**Re:** BusConnects Belfield/Blackrock to City Centre Core Bus Corridor Scheme  
Co. Dublin

ABP case ref: 313509

## **BUSCONNECTS CORE BUS CORRIDORS BELFIELD/BLACKROCK SCHEME**

Figure 1 NTA's 'Dublin-style' junction at Tonleeg Road

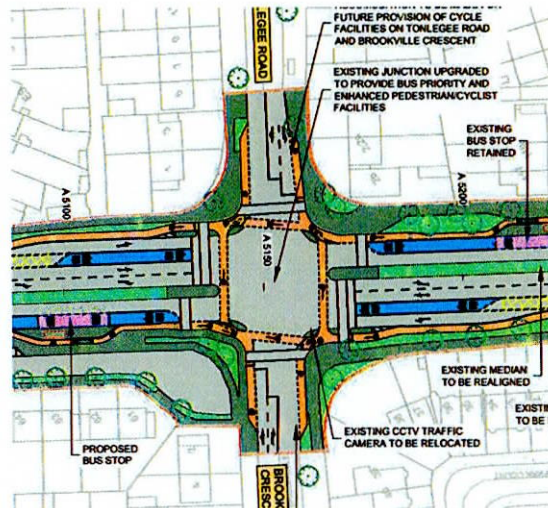
The primary junction design proposed by the National Transport Authority, the 'Dublin-style' junction (Figure 1), was designed by the NTA and does not follow international best practice in junction design.

When compared to the proven Dutch junction, the NTA's design poses a great risk of left-turning drivers crashing into cyclists and has larger crossing distances for pedestrians. The few existing examples of this NTA design in Dublin has been widely regarded as unsafe. We request that the NTA use Dutch-style junctions (Figure 2) or CYCLOPS junctions (Figure 3) throughout the project.

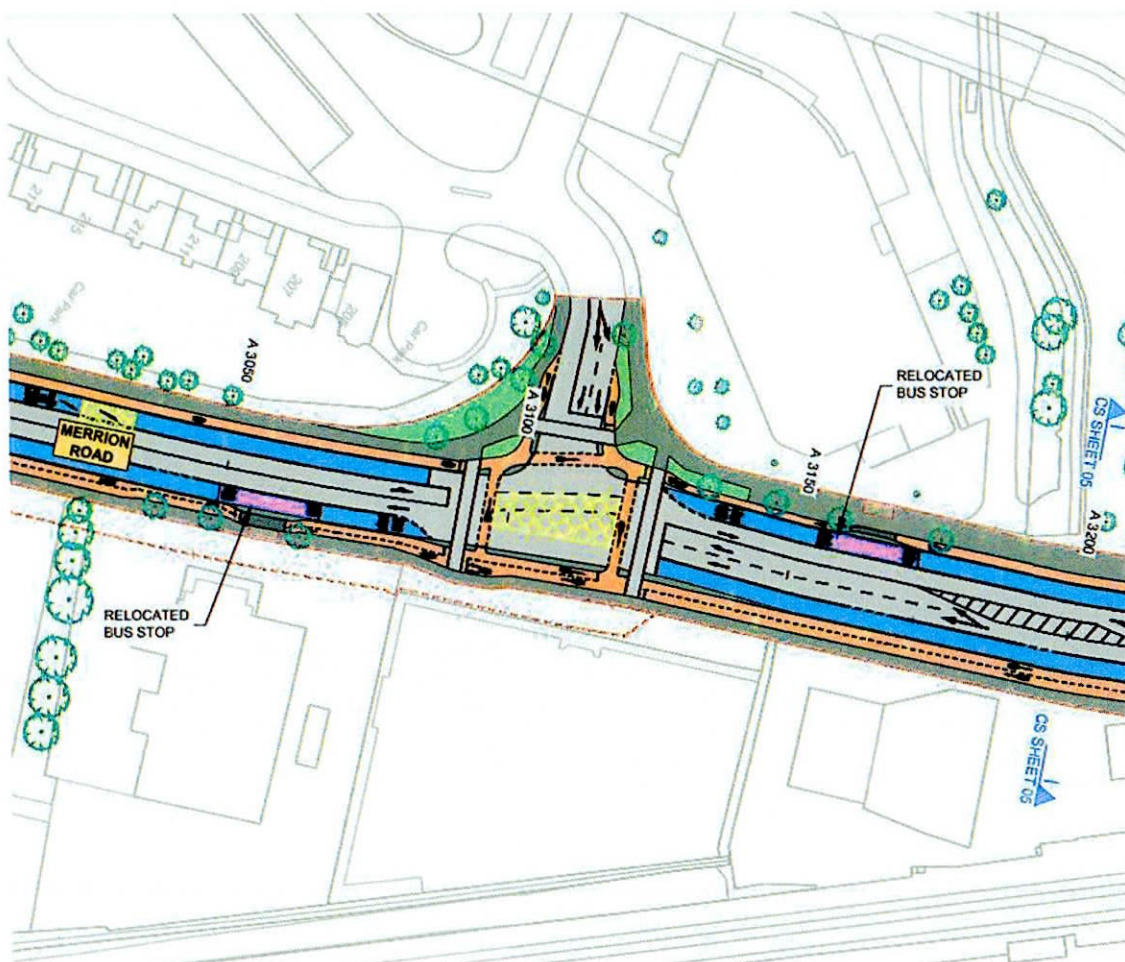
Furthermore, many four-way junctions are missing pedestrian crossings entirely on one or more legs. These missing crossings mean a pedestrian may need to wait for three lights — or more in the case of two-stage crossings — just to cross the street and continue their journey.

We also request that a pedestrian crossing be installed on Fitzwilliam Street at Fitzwilliam Lane.

*Temple Hill Requested Option - Additional stop on the outward side of the eastern arm*

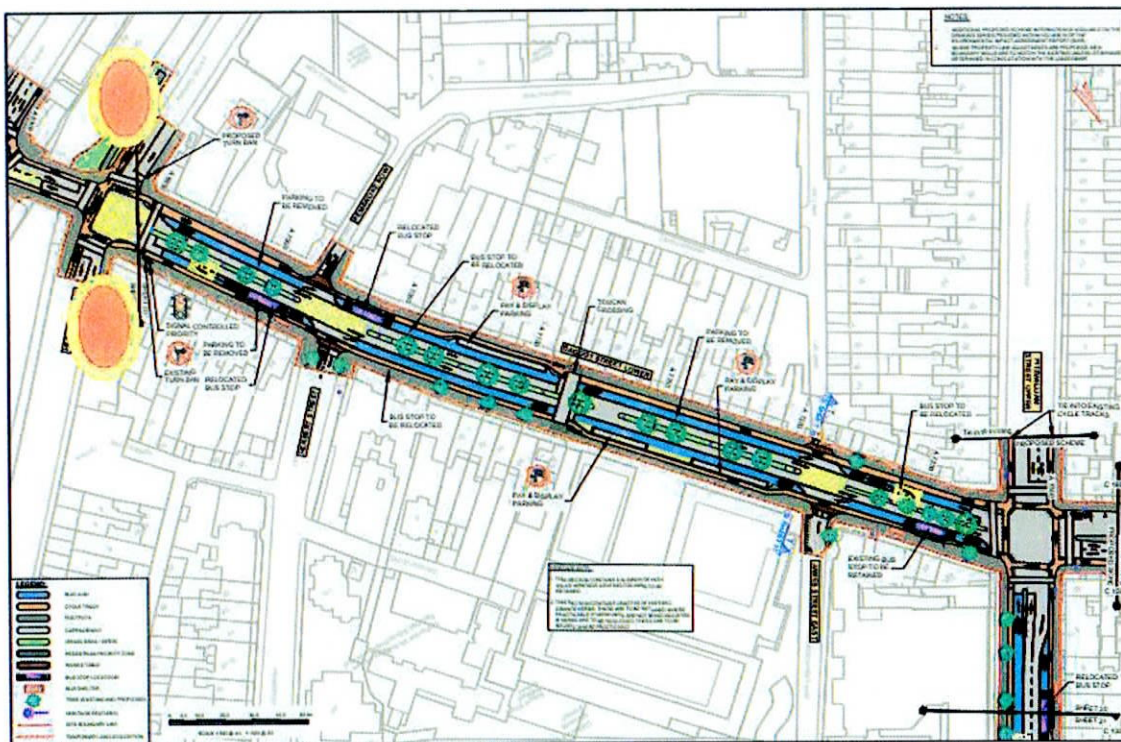
The proposed stops on Temple Hill are located on the outward sides of the north and south arms of the junction with Monkstown Road and will serve routes B3, B4 & 98 in the northbound direction and routes B4 & S8 in the southbound direction. However, routes B3, S8 & 98 are not served in the eastbound direction, which means that interchange cannot be made between all routes in all directions.

We believe that the most appropriate solution is for an additional bus stop to be placed on the outward side of the eastern arm of this junction, on Monkstown Road. A stop on the eastern arm would serve routes B3, S8 & 98 in the eastbound direction, and would allow for a full interchange between routes B3, B4 & 98 and the S8 Southern Orbital Route.

We request that the board modifies the scheme to require an additional bus stop on the outward side of the eastern arm of this junction, to allow for easy interchange between all routes and directions. We also note that such an additional stop would be partly within the scheme boundaries and would necessitate minor changes to other aspects of this scheme, and therefore should be provided as part of this scheme rather than left to another scheme.

*Baggot Street Lower Requested Option 1 - Additional stops on the outward sides of the Wilton Terrace and Herbert Place arms of the junction*

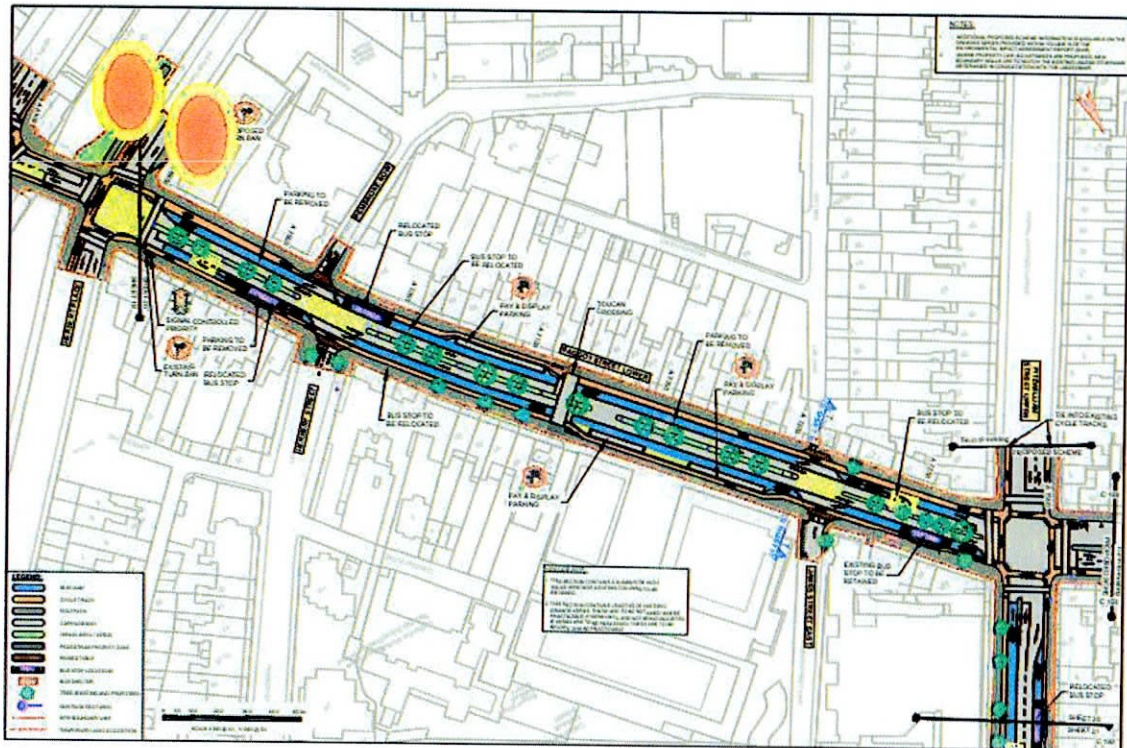
However, on Wilton Terrace/Herbert Place, it is unclear where the nearest stops which could serve the O Inner Orbital Route will be located. It is important that stops for the O Inner Orbital Route are located close to the junction to facilitate easy and legible interchange between the B Spine and the O Inner Orbital Route. Options for this could involve placing stops on the outward sides of the Wilton Terrace and Herbert Place arms of the junction, or placing a stop pair on either the Wilton Terrace or Herbert Place arms of the junction.

We request that the board modifies the scheme to require additional bus stops on Wilton Terrace and/or Herbert Place, to allow for easy interchange between the B

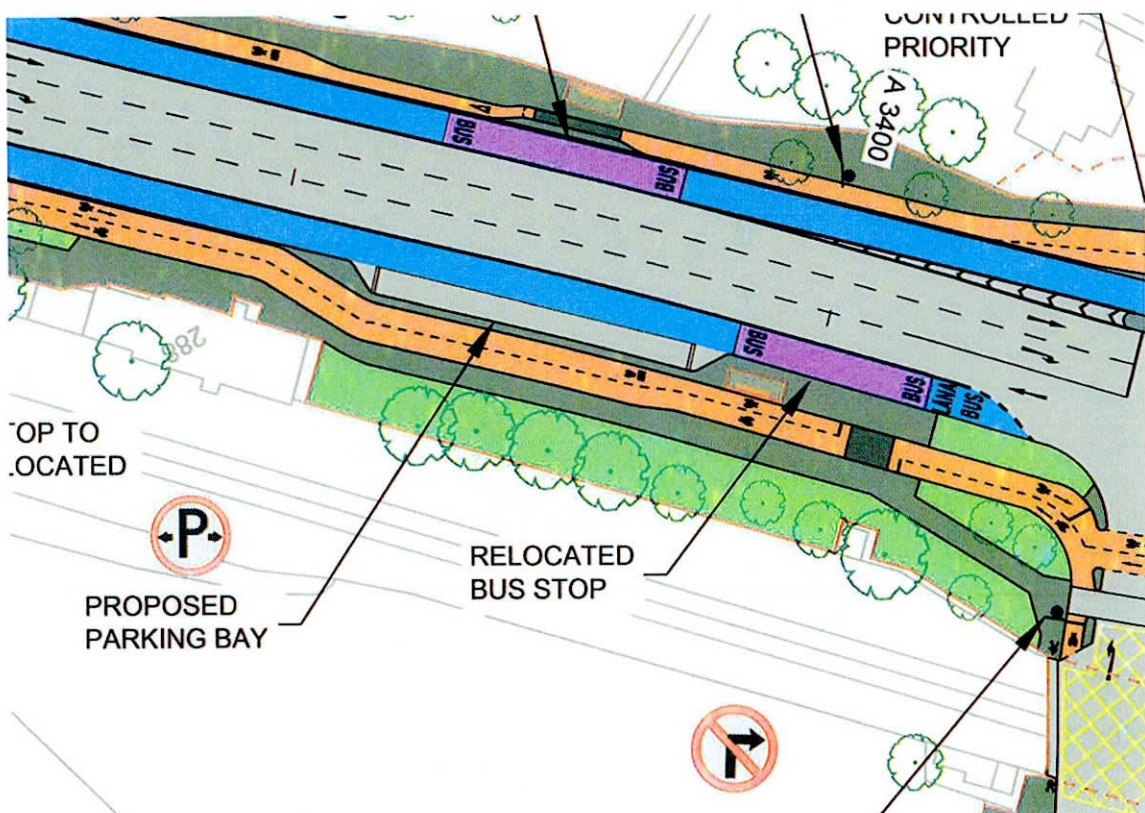
There are some parking spaces being added within this proposal that seem superfluous and, in some cases, dangerous, that we would like you to reconsider. Whilst we welcome the redesign & removal of the filter lane at Merrion Gates, a number of parking bays have been added which we think are unnecessary.

There is no current provision for parking at this location and there does not seem to be a demand either. There are no retail or residential buildings that they will serve and, northbound drivers would be encouraged to perform a dangerous U-Turn to use the parking bays.

It would be our recommendation to remove these parking bays from the plans and extend the cycle tracks 'straight-run' before it is adjusted behind the bus stop. This will allow for greater pedestrian space coming from or going to Strand Road.

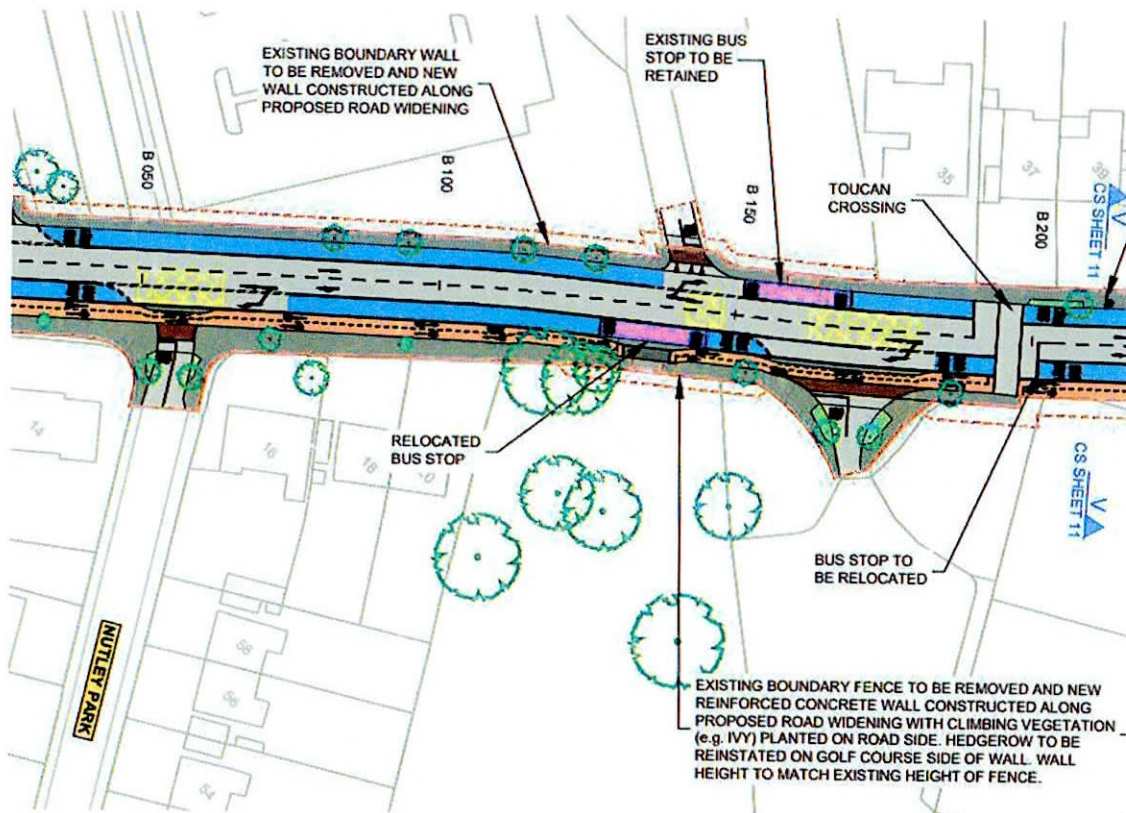
The proposed design for Nutley Lane is inadequate for pedestrians. The removal of the footpath to facilitate two-way general traffic is a regressive step and one that should be avoided at all costs. We would propose making Nutley Lane one way for general traffic to implement cycle lanes, bus lanes and footpaths on both side of the road.

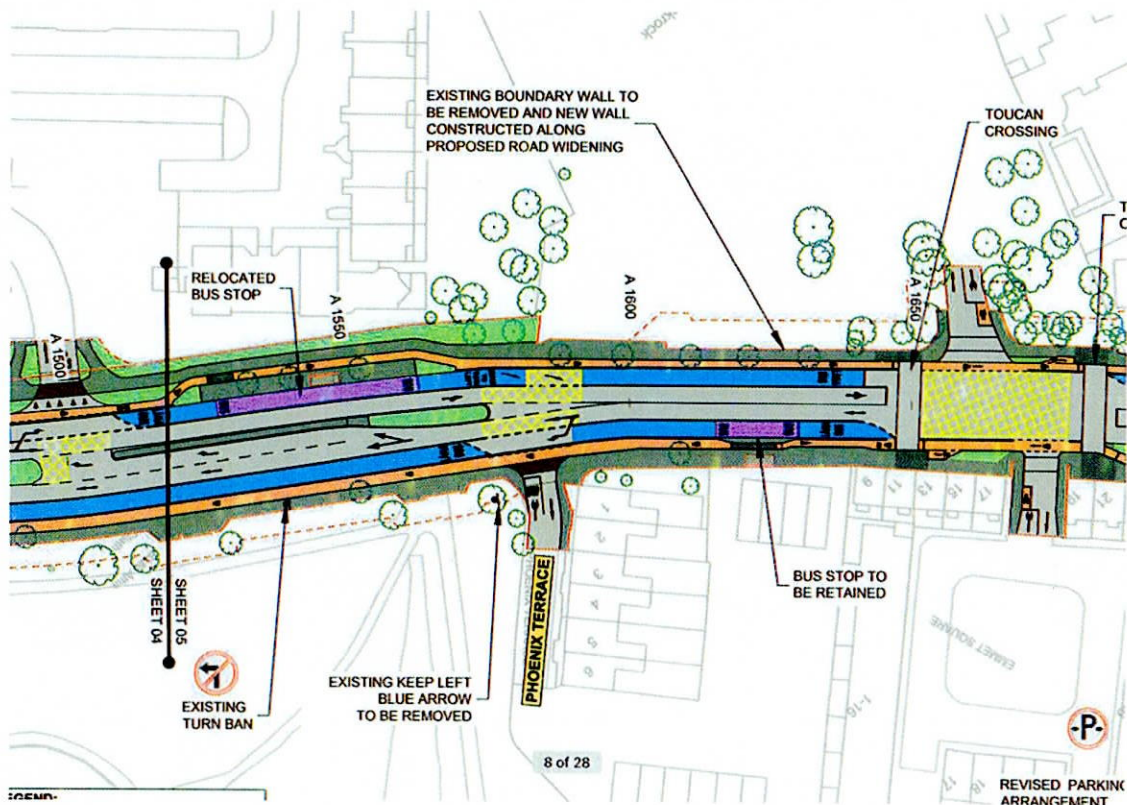
There are a number of examples on the map where we believe the yellow boxes should be extended to avoid vehicles being stranded in dangerous areas and impeding active travel users.

Two examples of this are on Strand Road at Merrion Gates where a traffic signal is to be placed earlier at the junction than the existing location and the Rock Road at Phoenix Terrace.

It would be our recommendation to extend these yellow boxes so they cover the entirety of the road area up to the signal point. It is very easy to see that cars will continue to queue up right at the level crossing gate at strand road, breaking the red light and blocking access to the beach area.
